T32MZ SOFTWARE UPDATE CHANGES

(Editor Version: 3.4 Encoder version: 1.2)

2. Futaba ESC, Hobbywing ESC telemetry compatible

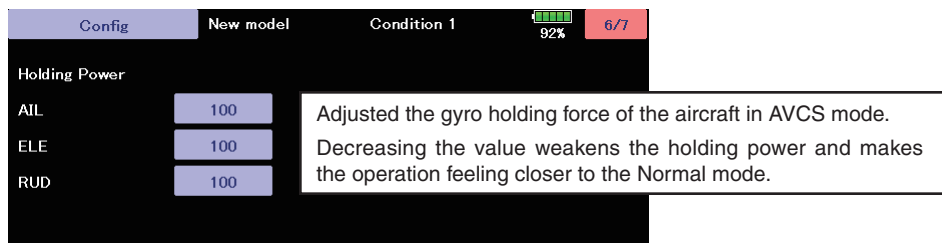
Supports the telemetry function of the Futaba sensor "Futaba ESC" and the Hobbywing sensor "Hobbywing ESC".

4.Add R.P.M. display : Gov Basic

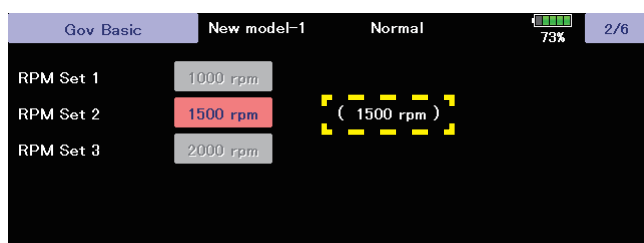
The number of revolutions of the governor setting is displayed on the governor basic screen of the gyro setting.
